Isthmus.

RE: LAKEVIEW QUEENSTOWN COVID 19 RECOVERY FAST TRACK PANEL INFORMATION RESPONSE.

Figure 1: The 2009 Landscape and Urban Design Viewpoints.

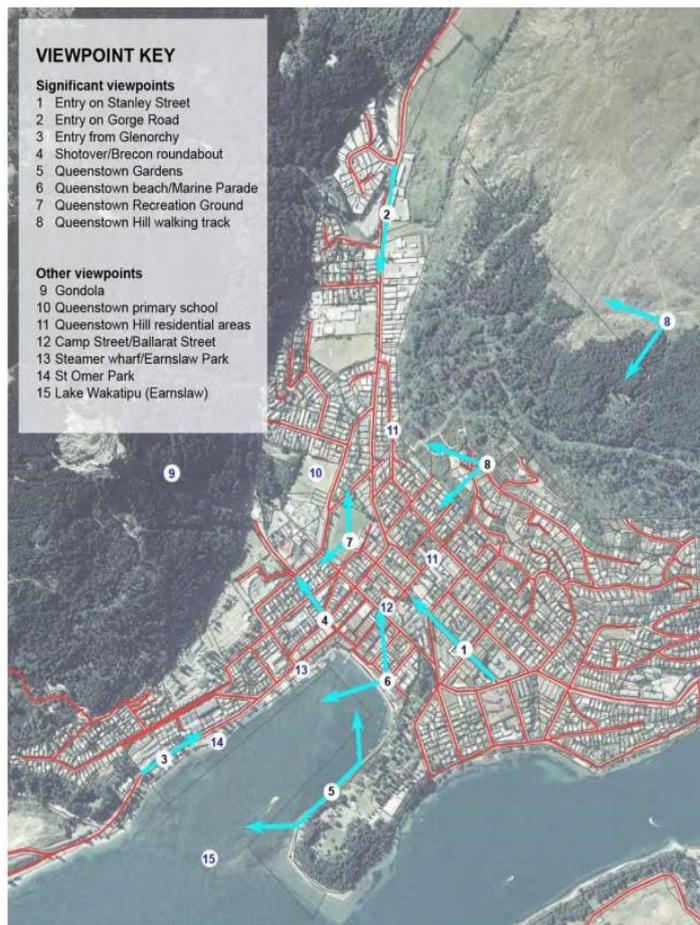
- 5. Please provide equivalent simulations of the proposed development from the viewpoints contained in the Landscape & Urban Design Assessment prepared by Helen Mellsop and Nick Karlovsky for Queenstown Lakes District Council, dated November 2009, which supported Plan Change 50 to the Queenstown lakes District Council Operative District Plan.*

Please see the figure below for the location of each viewpoint. This figure can be found on page 21 of the Landscape and Urban Design Assessment.

We request the Applicant to assess the PC50 and proposal's comparative viewpoints and provide expert comment on the proposal's consistency with the outcomes visualised at the time of PC50, as part of its case that the proposal is in line with PC50's provisions.

3. The 2009 Landscape and Urban Design Assessment included a series of photographs that related to the entire PC50 site and was used as a baseline for understanding the issue of height, rather than specifically assessing the full package of provisions for PC50. The photographs assisted in the understanding of the broader visual impacts of the height of development, including development in the northeast end of the site, adjacent to the Brecon Street Cemetery.

4. In 2014 Clinton Bird and Fearon Hay Architects prepared further urban design assessment for PC50, including illustrations of development to the PC50 height limit from a number of viewpoints, including many of those used in the 2009 Landscape and Urban Design Assessment. The viewpoints used in the Landscape and Visual Assessment for the Lakeview proposal are based on the viewpoints from the 2014 Clinton Bird and Fearon Hay work.

5. The Clinton Bird / Fearon Hay simulations from the viewpoints were boxes illustrated to the maximum height of PC50. They were essentially 'bulk and location diagrams' and were not articulated or designed buildings (as is common when assessing PC provisions). The photographs used for the PC50 images were taken during the winter, with low cloud and impaired visibility. The illustrations were attached to the evidence of Clinton Bird.
